ORIGINAL RECEIVER UNIT OF BUSH MODELS TV22, TV24, TUG24

## MODIFICATIONS

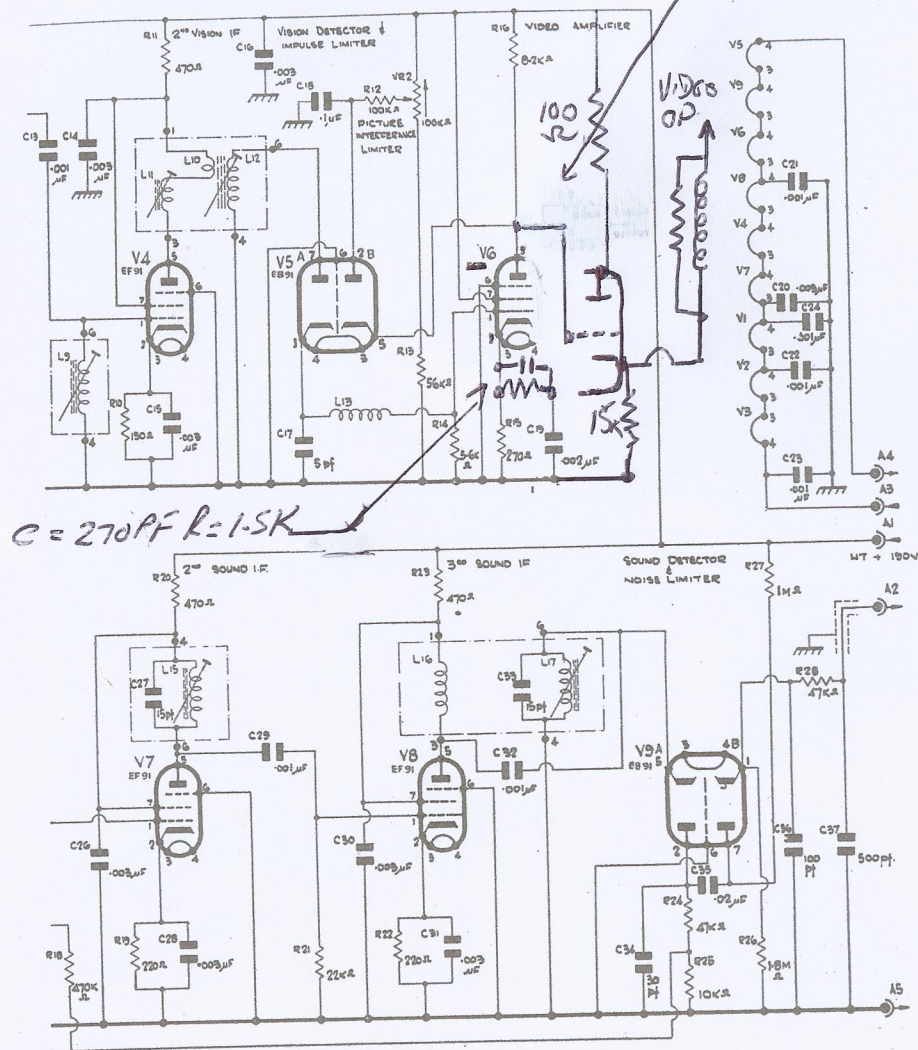
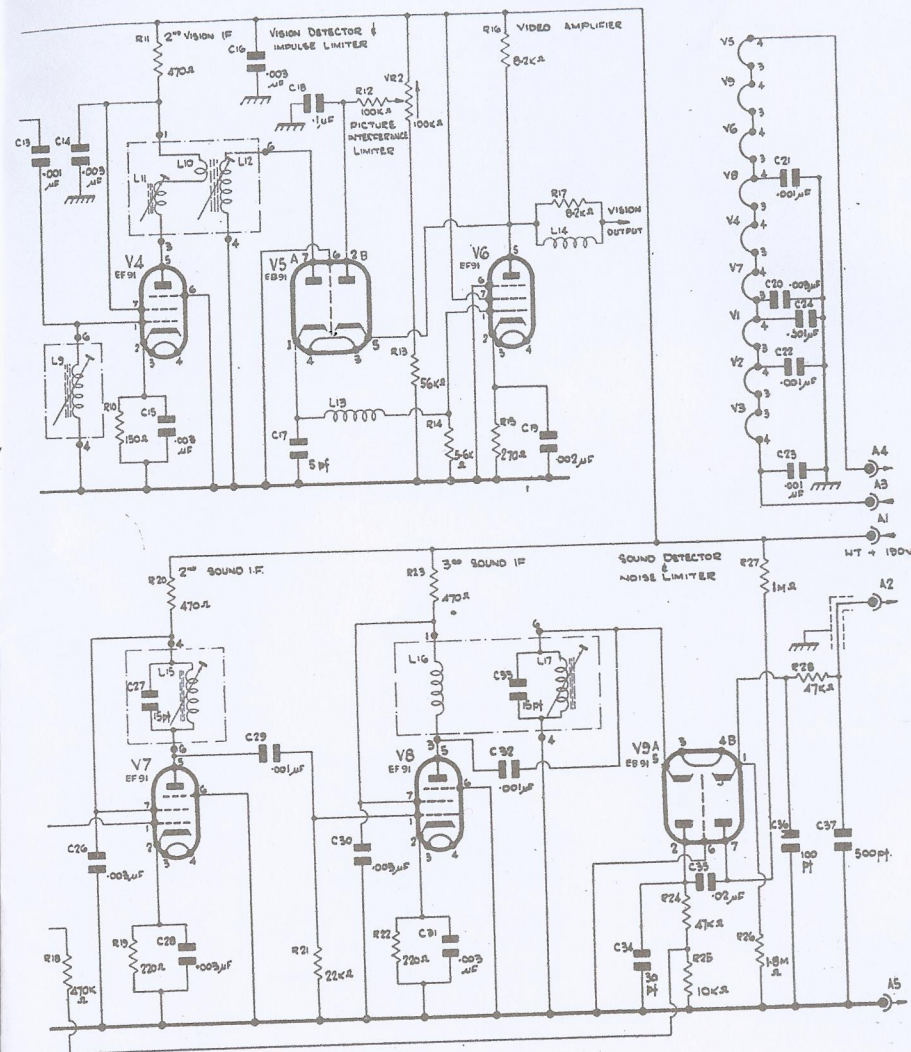
In later models an image filter consisting of a parallel tuned circuit in series with the aerial lead has been fitted. The tuning range is 80-100 Mc/s., and should be tuned to give minimum output of the unwanted signal. The filter core must be adjusted from the underside of the receiver chassis.

R2 and R9 have been changed to 120 ohms.

R7 and R11 have been changed to 680 ohms.

C2 has been changed to 300 pF.

Connections to L1/2: Delete No. 4 and substitute No. 1.
